ADDENDUM #1 - ARCHITECTURAL

GROUND LEVEL
STRIPING PLAN

CONSTRUCT 525 SPACE
PARKING GARAGE

A101

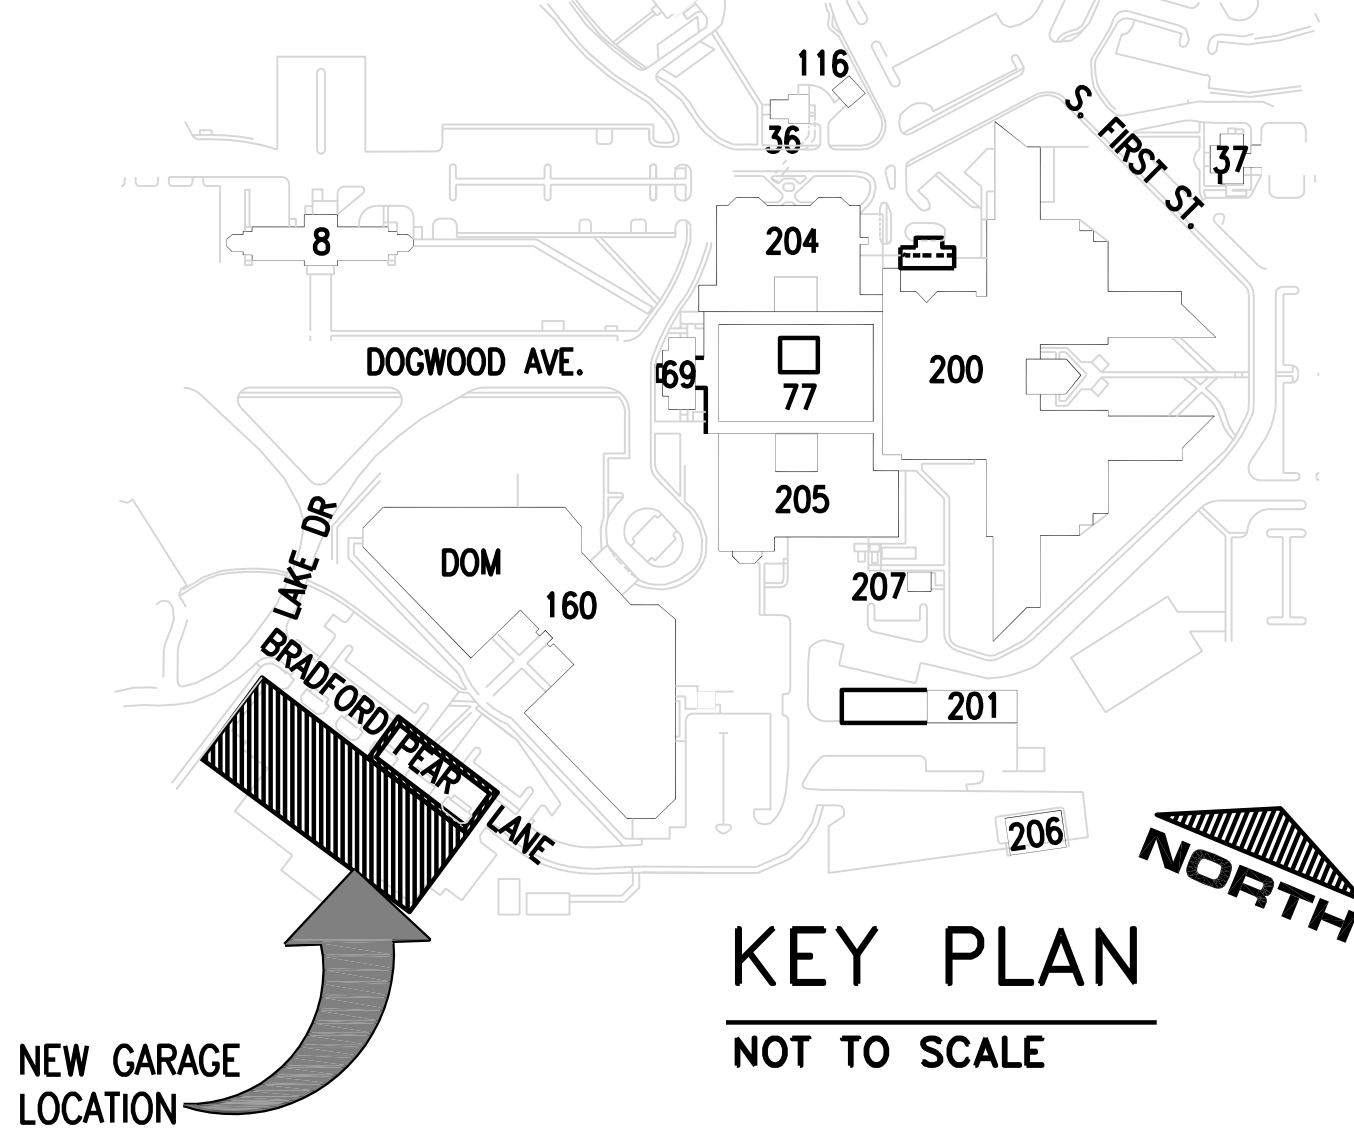
- All changes for lower numbered Alternates also apply to the Alternates with higher numbers.
- ALTERNATE NO. 1:**
 - Delete Stair #4 and Elevator #4 including the Elevator Lobby at Level 4.

- Re-layout and stripe the area in front of the stairs and elevators and the crosswalk for additional parking spaces at Levels 3 and 4.
 - Delete all signs related to Stair #4 and Elevator #4.

- ALTERNATE NO. 2:**
 - Delete brick veneer from all precast members.
- ALTERNATE NO. 3:**
 - Delete Level 5 down to grid C-11 to 12 on Level 4.
 - Delete the Elevator Lobby construction.

- Relocate the Elevator Control Room from Level 4 to the Ground Level on the west side of the elevator tower.
 - Re-layout and stripe the area at the former Elevator Control Room for additional parking spaces at Level 4.

- Delete all Level 5 signs except inside the stair towers. Delete all overhead hanging signs for Level 4.
- ALTERNATE NO. 4:**
 - Delete the Maintenance Room.

- Delete Level 4 down to grid C-11 to 12 at Level 3.
- Relocate the Telecom Room from Level 3 to the Ground Level in the Mechanical Room.
- Re-layout and stripe the area at the former Telecom Room for an additional parking space at Level 3.
- Delete all Level 4 signs except inside the stair towers. Delete all overhead hanging signs for Level 3.

- Delete Level 3 down to grid C-11 to 12 at Level 2.
- Delete all Level 3 signs except inside the stair towers. Delete all overhead hanging signs for Level 2.

Relocate two snow gates to what will now be the third or top level

Build Stair Tower #3 to full height. Block section of stair at third level to prevent patrons from ascending above third level and seal all door openings above to allow waterproofing and future reopening of doors.

Build Stair Tower #1 to full height. Block stair at third level to prevent patrons from ascending above third level and seal all door openings above to allow waterproofing and future reopening of door.

Build Elevator Tower #2 to full height. Set hoisting equipment at third level and provide for elevator service to only the 1,2, and 3rd levels. Block all elevator openings above to waterproof and seal for future doors. In that there will be no elevator vestibule as shown on the 5th level, on 3rd level install a canopy covering both elevator doors similar to 3/A415 with bracket supports on either side of doors and one support between elevator doors. Canopy shall extend 3'-0" beyond each outer door jamb.

All Stair Tower and Elevator Tower downspouts shall be extended to what will now be the top level.

Relocate elevator control room and door to ground level adjacent to and west of Elevator No.2.

Relocate Telecom Rm and door from 3rd Level to Ground Level. Locate Telecom room in Mechanical Room by shifting Door 103 north 8' and installing Telecom Rm in south east corner of Mechanical Room. Locate Telecom Room door so that it opens into garage similar to swing of Door 103.

All access ladders to roof of stair and elevator towers shall be extended from the third level to roof with 1/4" x 2" safety cage extended as well. Ladder and Cage shall be so designed to allow eventual removal in sections and installation of garage floor levels in the future.

Relocate canopies indicated over doors 502 & 500 to doors 302 & 300 respectively.

Relocate two snow gates to what will now be the second or top level

Build Stair Tower #3 to full height. Block section of stair at second level to prevent patrons from ascending above second level and seal all door openings above to allow waterproofing and future reopening of doors.

Build Stair Tower #1 to full height. Do not block stair at first run of stair leading from 2 level to intermediate level leading to egress point at grade. Stair tower #1 is to be blocked from the second level intermediate level to prevent patrons from ascending above the intermediate level.

Build Elevator Tower #2 to full height. Set hoisting equipment at second level and provide for elevator service to only the 1,2 and 2nd levels. Block all elevator openings above to waterproof and seal for future doors. In that there will be no elevator vestibule as shown on the 5th level, on 2nd level install a canopy covering both elevator doors similar to 3/A415 with bracket supports on either side of doors and one support between elevator doors. Canopy shall extend 3'-0" beyond each outer door jamb.

All Stair Tower and Elevator Tower downspouts shall be extended to what will now be the top level.

All access ladders to roof of stair and elevator towers shall be extended from the second level to roof with 1/4" x 2" safety cage extended as well. Ladder and Cage shall be so designed to allow eventual removal in levels and installation of garage floor levels in the future.

Eliminate canopy indicated over door 502.

Relocate canopy indicated over door 500 to door 200.

Install a new canopy over now exterior stair located between column line B7&B8. Canopy shall be gable roof shape and framed with 4"x4" steel tube frames set in concrete with 2"x2" purlins. Frames shall be located 1'-0" from face of building and then 2 bays of 4'-0" each. Set frame columns minimum of 1'-0" outside of stair outer edge. Roofing shall be standing seam to match all other canopies in finish and color. Roofing shall overhang outside purlin by 8" and terminate in mfrs. recommended waterfall detail with a depth of 6".
